ADDENDUM NO: 01

PROJECT: Pendleton Elementary Roofing Replacement

PROJECT NO: 2026060

DATE: 07/24/26

DRAWING TITLE:
**SECTION
DETAILS**

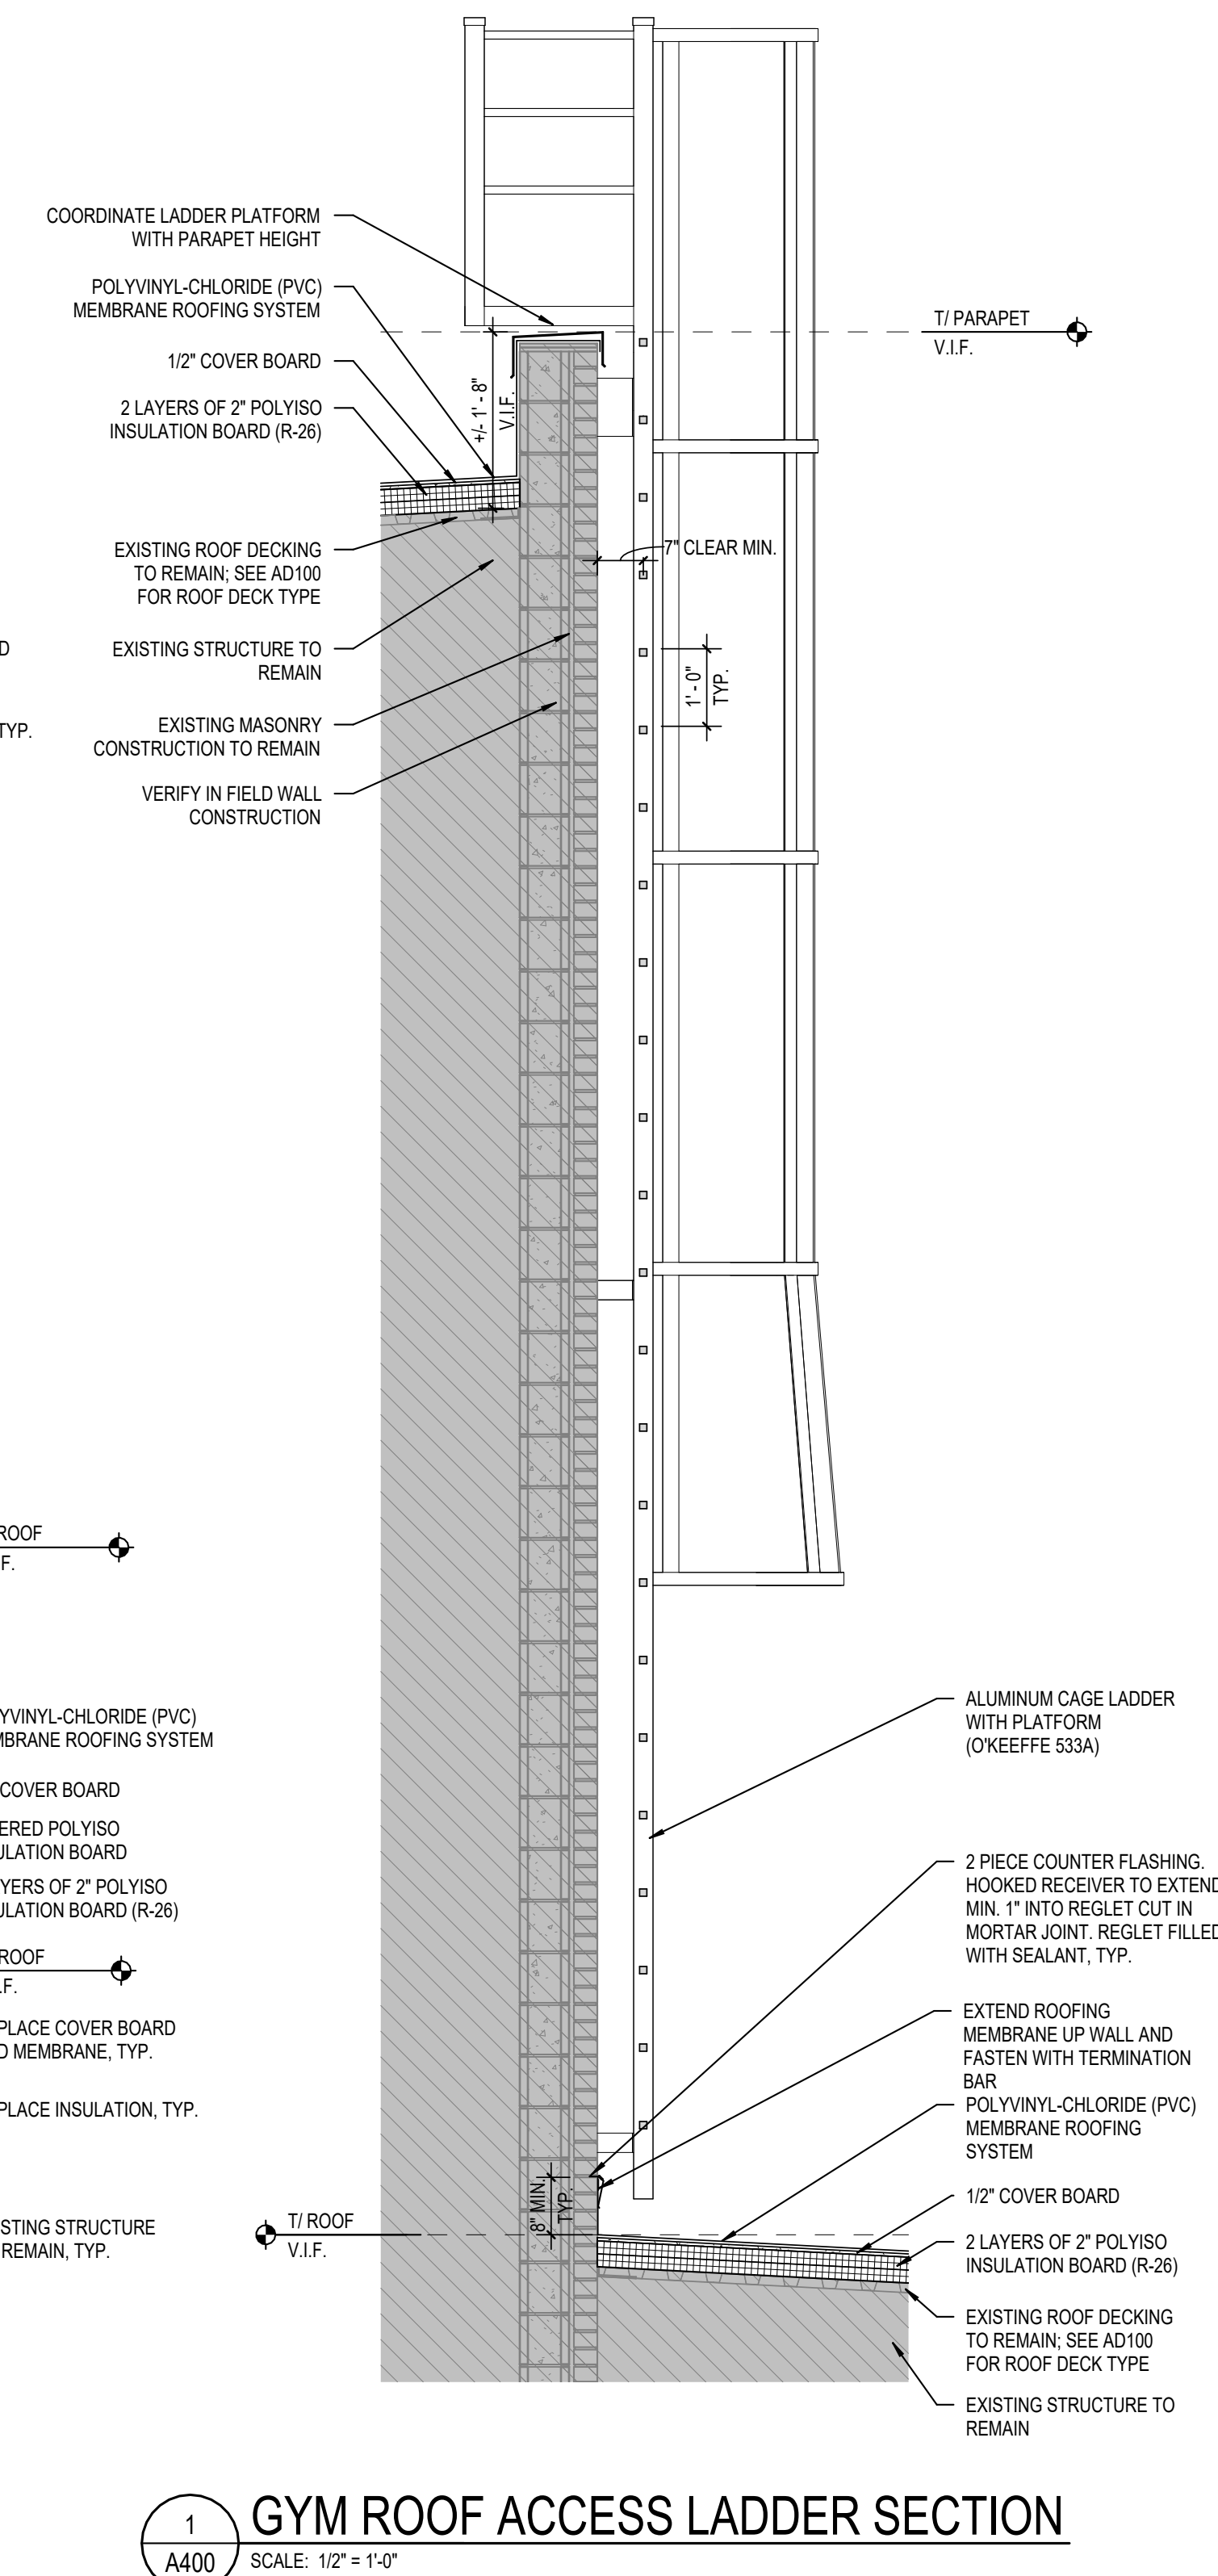
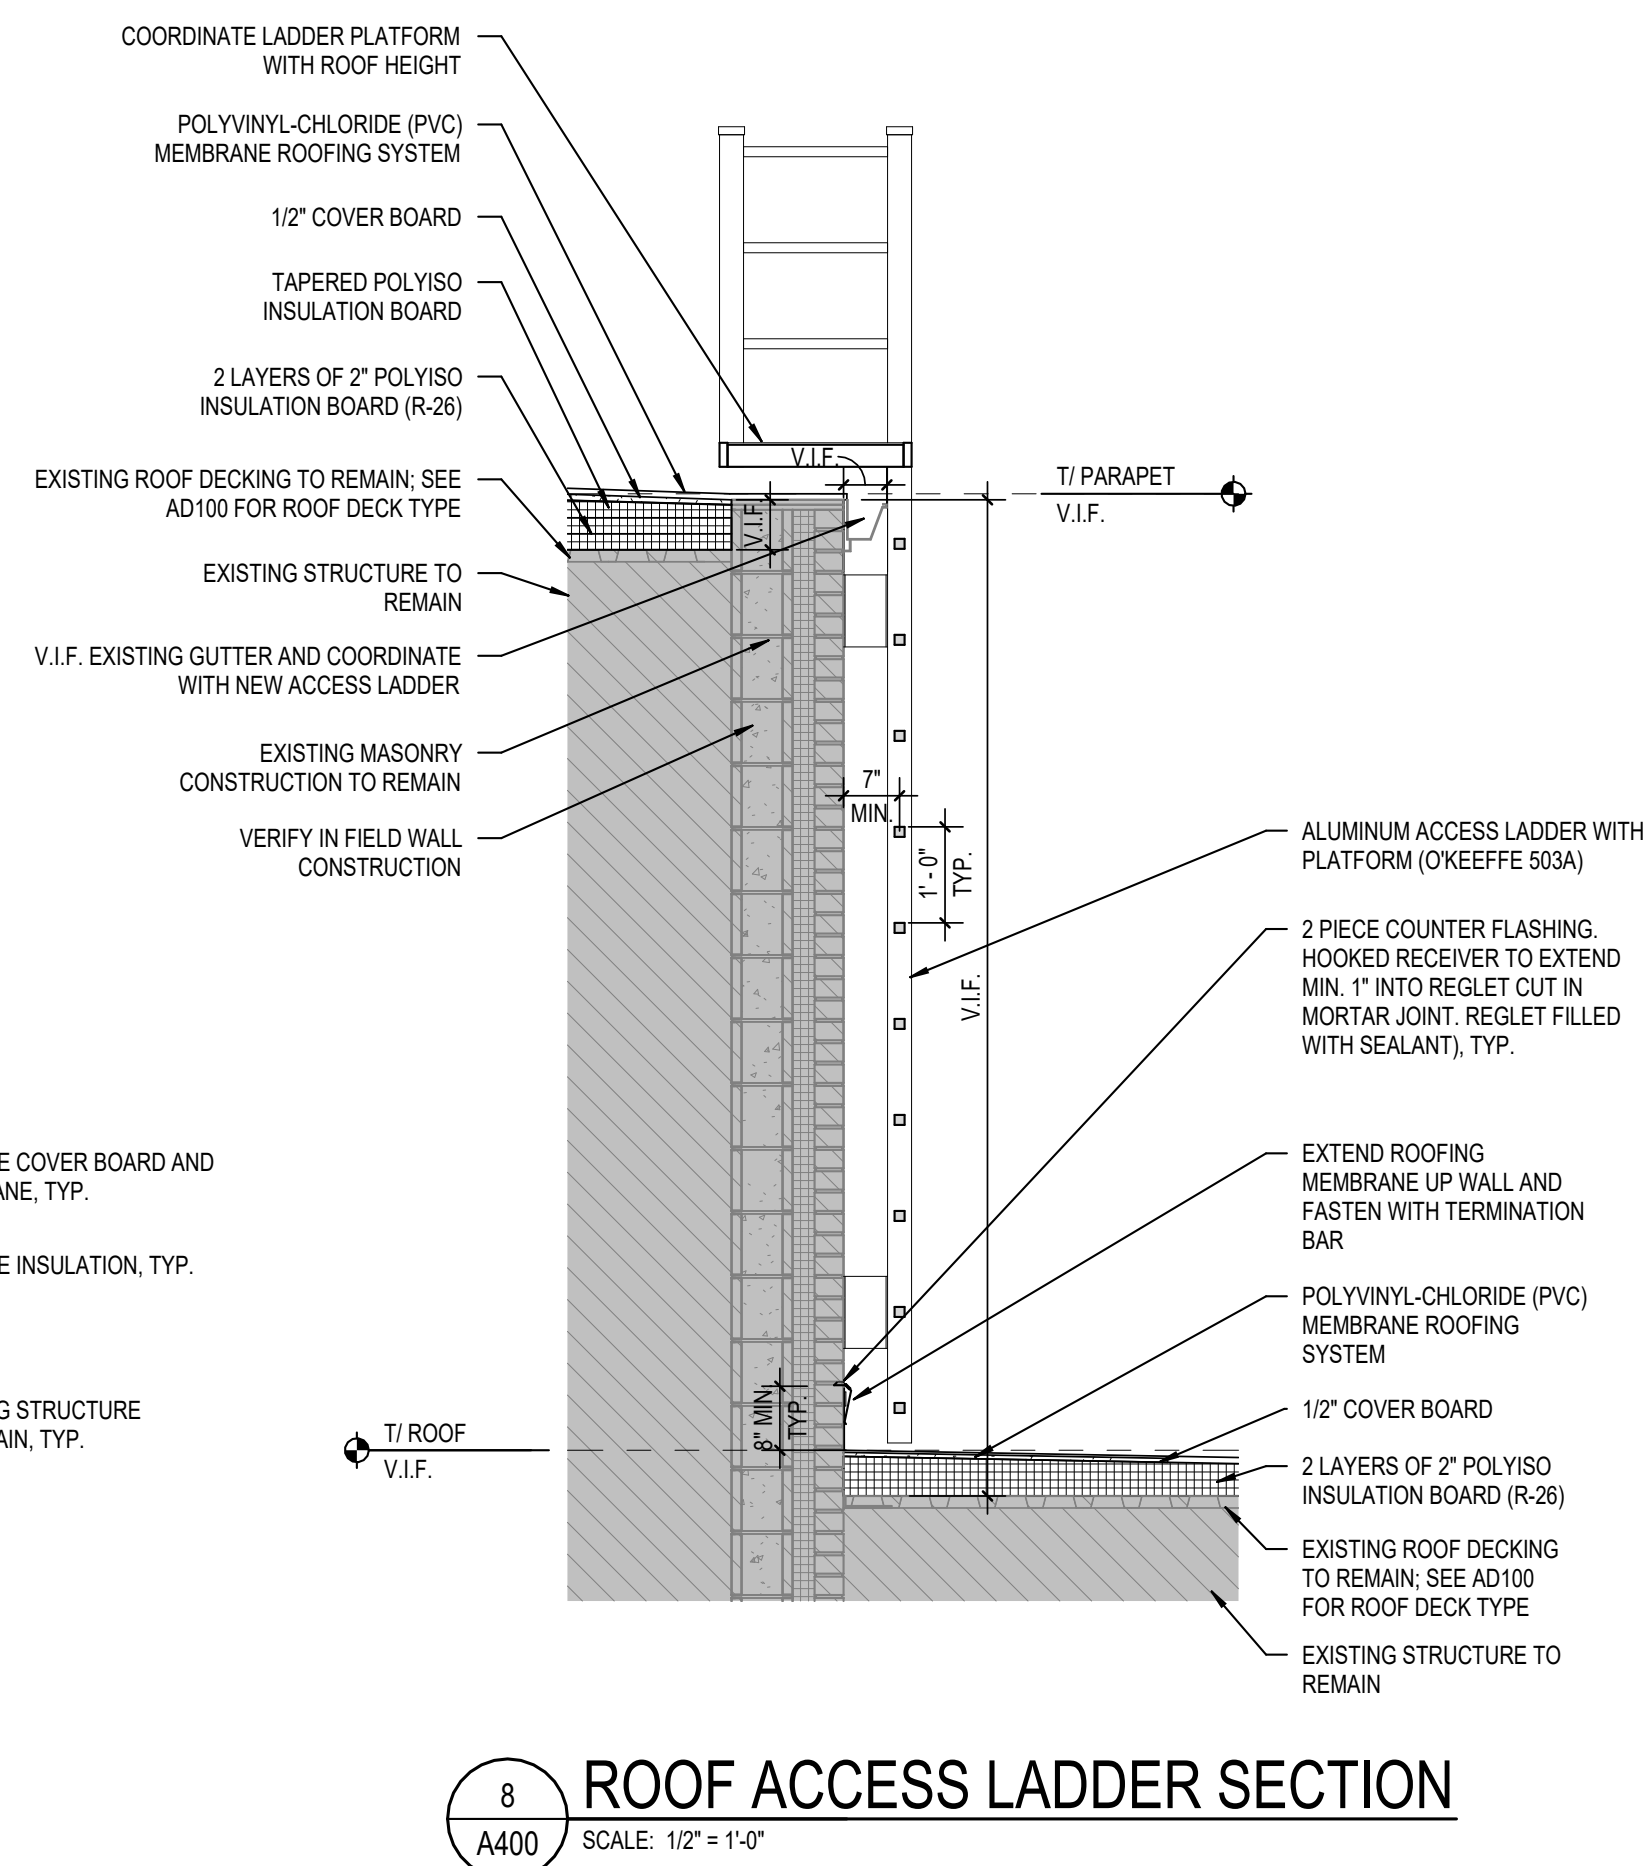
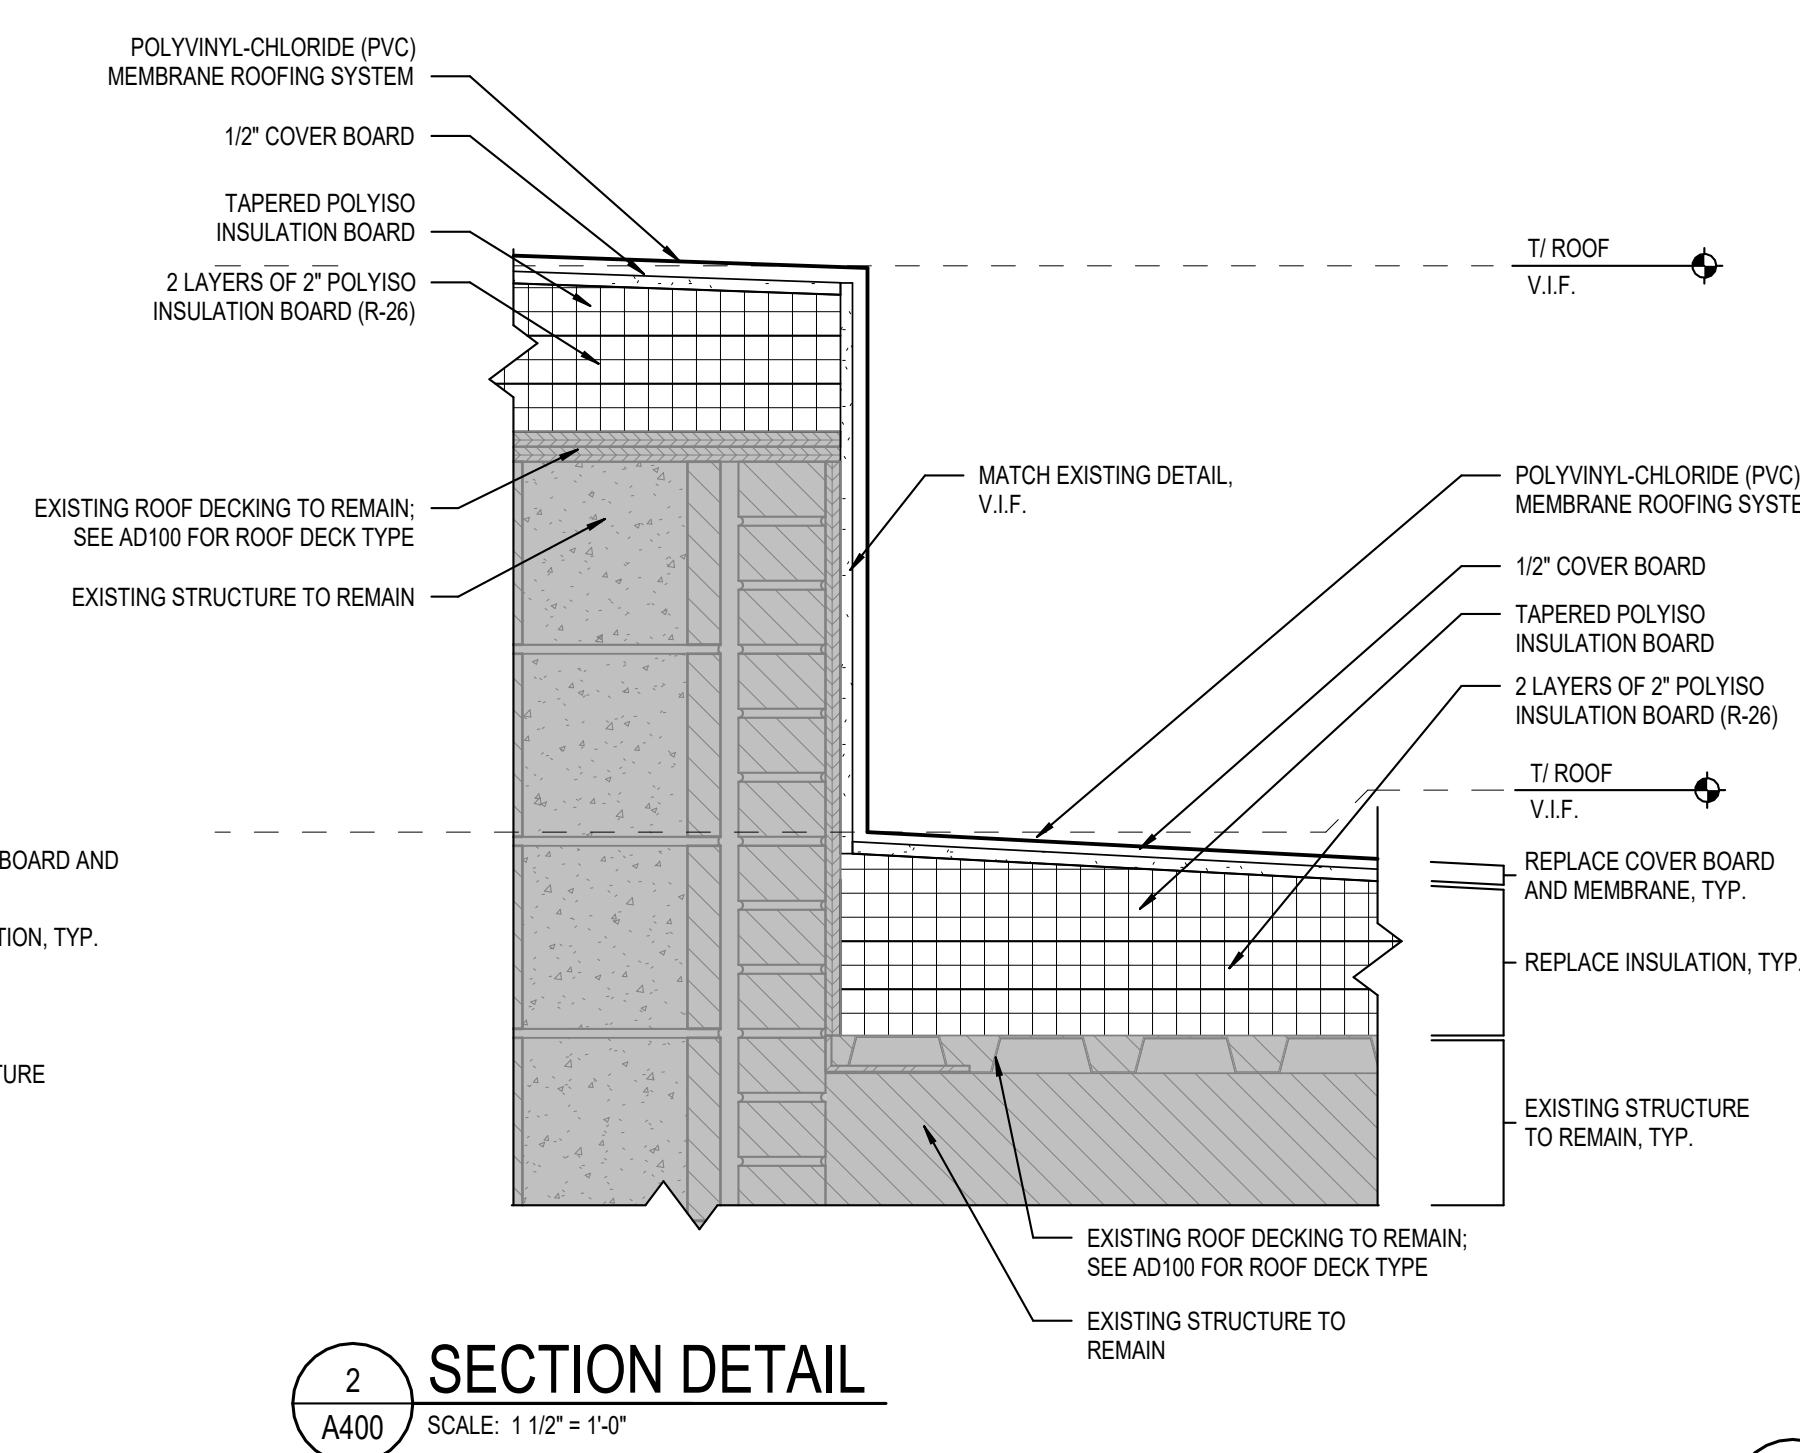
3.3 A400 – SECTION DETAILS

A. Revise all details to depict existing roof conditions.
